# STERLING RANCH ROAD CROSSING

# GRADING AND EROSION CONTROL PLAN

MAY 2022

CDR-226

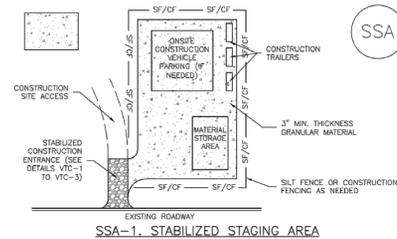
Delete "interim"

**STERLING RANCH ROAD CROSSING  
GRADING AND EROSION CONTROL PLAN**  
GEC PLAN

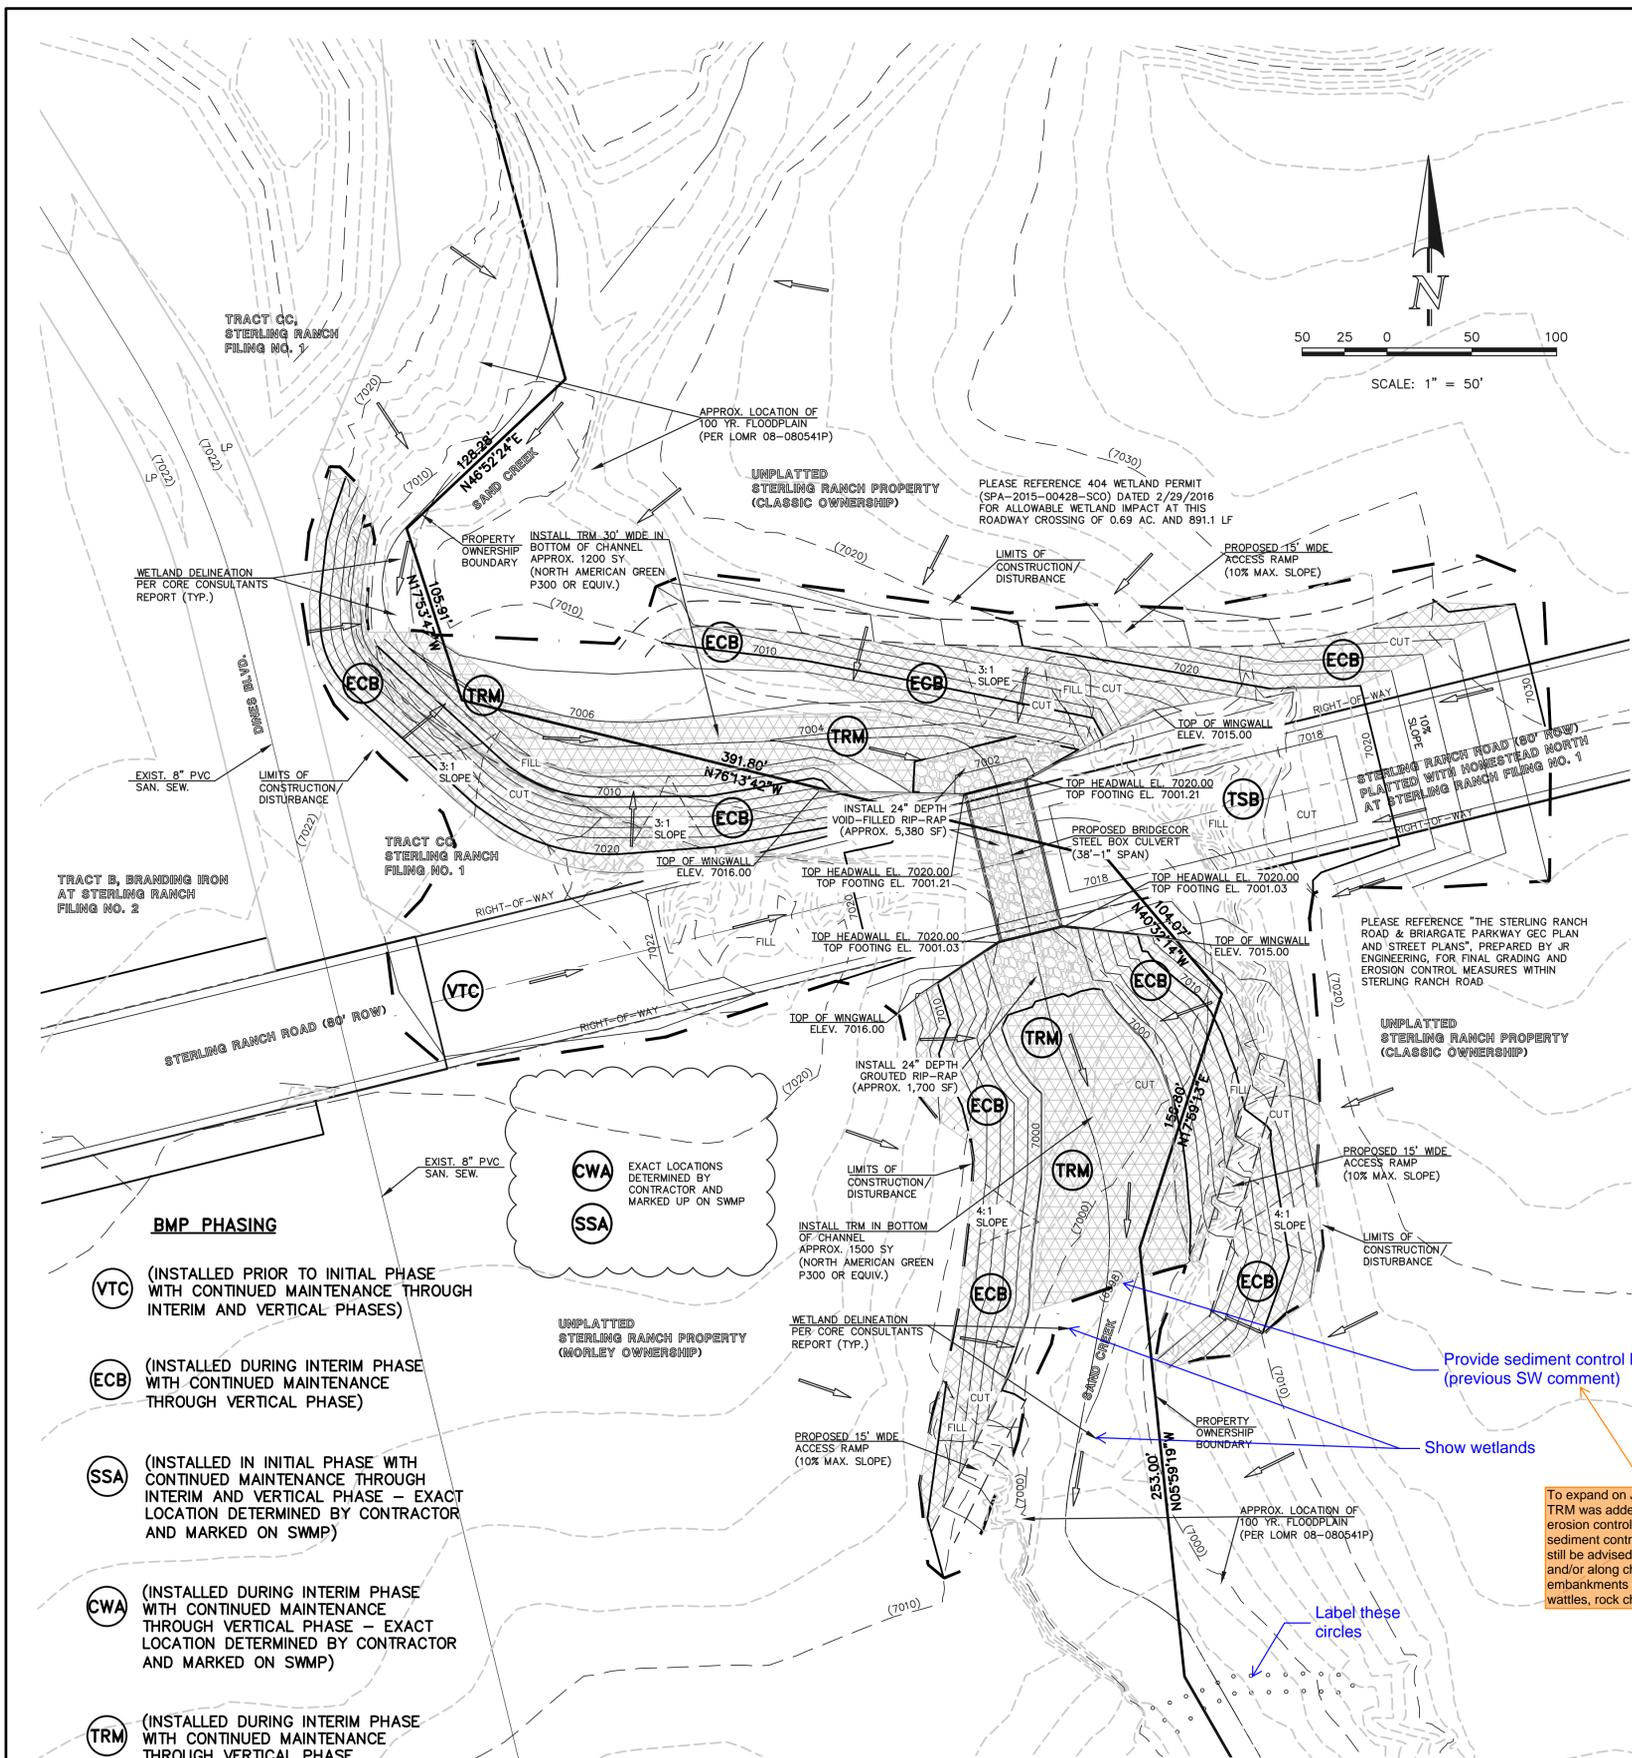
To expand on Jeff's comment, TRM was added, which is an erosion control BMP, but a sediment control BMP would still be advised within channel and/or along channel embankments (like straw wattles, rock check dams, etc)

Label these circles

Show wetlands

Provide sediment control BMP(s) (previous SW comment)
